SECTION 00 91 02
ADDENDUM NUMBER 2

DATE: AUGUST 30, 2022
PROJECT: KEN PICKERILL HOUSE RENOVATIONS
6350A MINKLER ROAD
YORKVILLE, ILLINOIS 60560
PROJECT NO: 19-429-1250
OWNER: KENDALL COUNTY FOREST PRESERVE DISTRICT
110 W. MADISON STREET
YORKVILLE, ILLINOIS 60560
TO: PROSPECTIVE BIDDERS / PLANHOLDERS OF RECORD

THIS ADDENDUM CONSISTS OF 2 PAGES AND DRAWINGS A311, A331, A700, S311, S321 & S400.

CANOPY FRAMING PLAN
SCALE: 1/4" = 1'-0" **1**

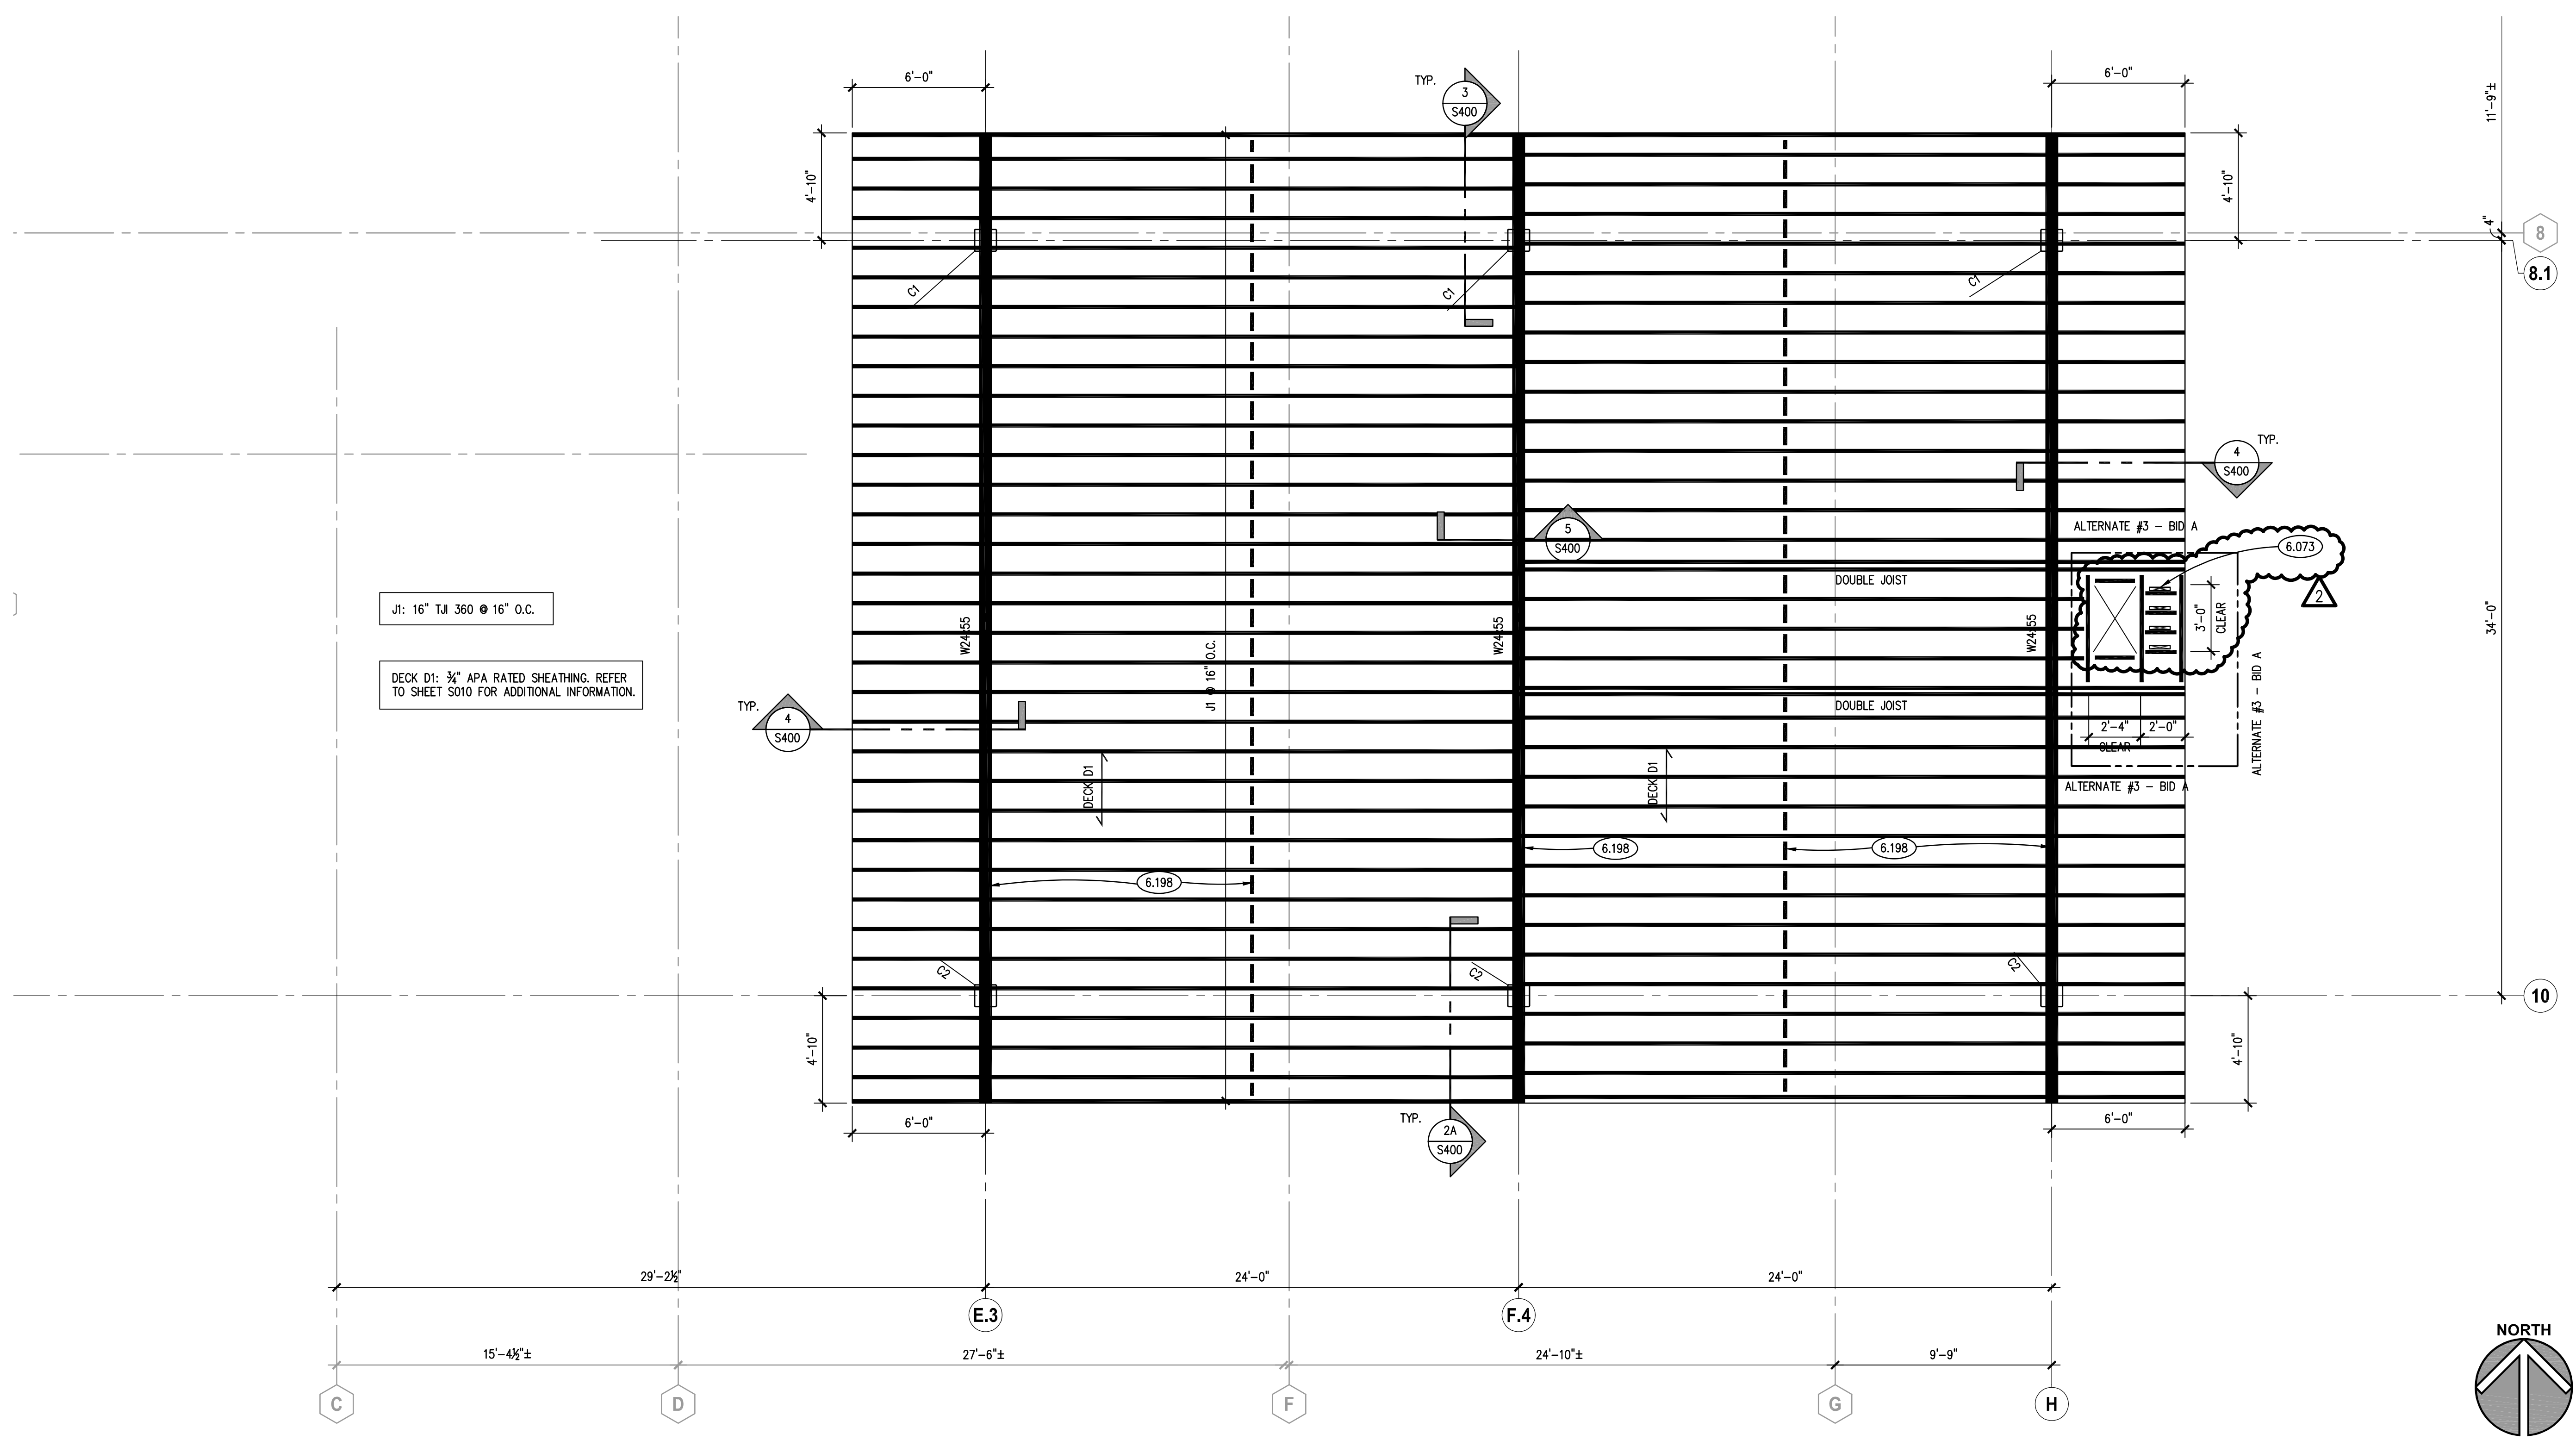
3.05 DRAWING S321 - CANOPY FRAMING PLAN

A. Revised Detail 1 - Canopy Framing Plan to indicate a smaller clear opening through the roof deck for the revised framed chimney structure. Added Keynote 6.073 describing chimney construction.

SECTION 5
SCALE: 3/4"= 1'-0"

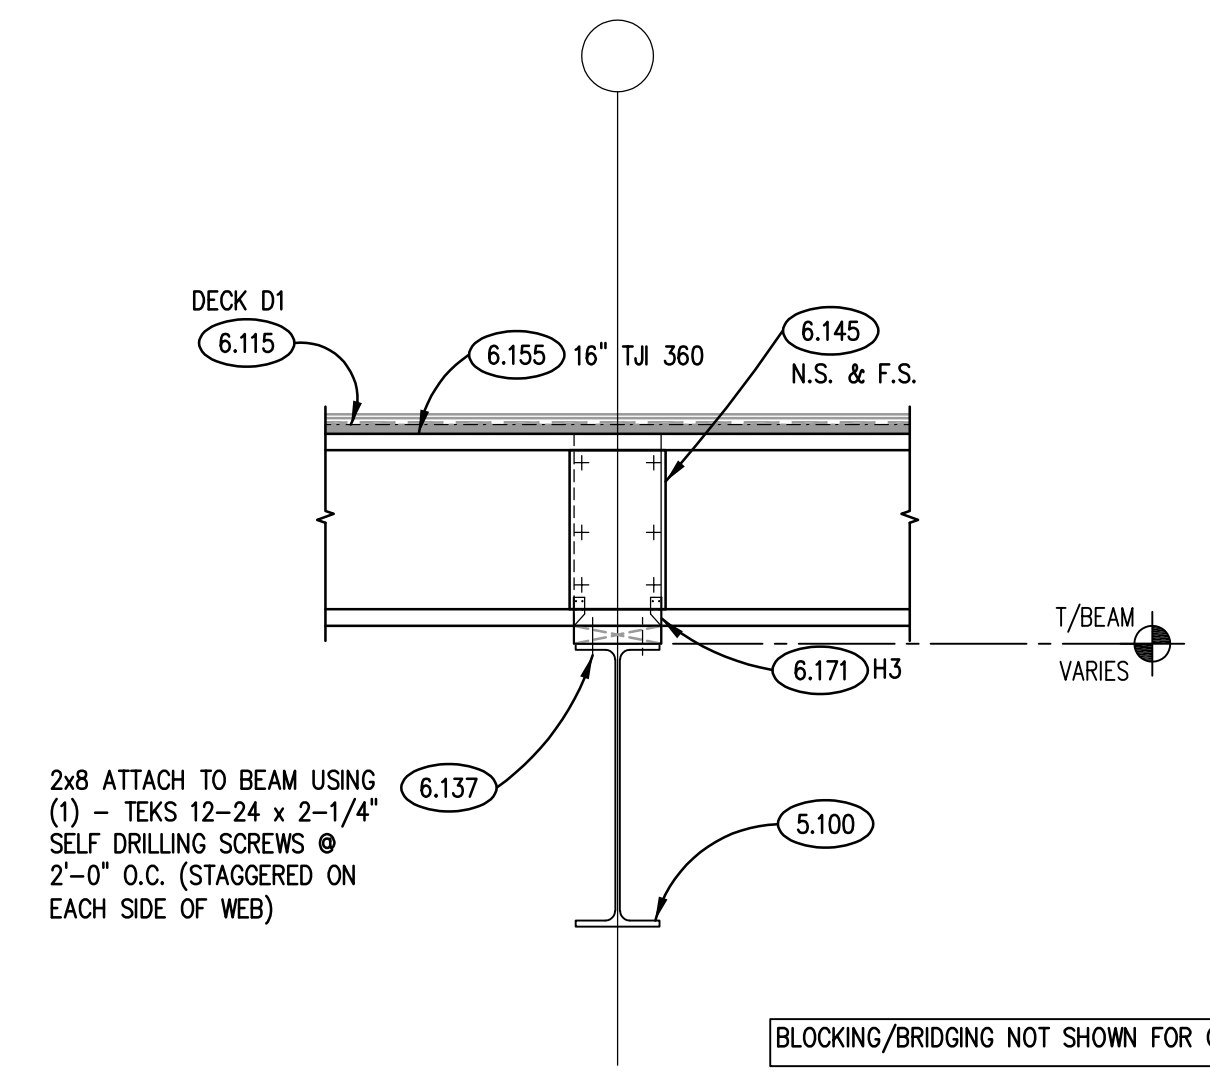
3.06 DRAWING S400 - FOUNDATION, FRAMING SECTIONS & DETAILS

A. Revised Detail 5 - Section Detail to include framed chimney foundation extension and chimney framing system. Added Keynotes as indicated in Revision Cloud #2.
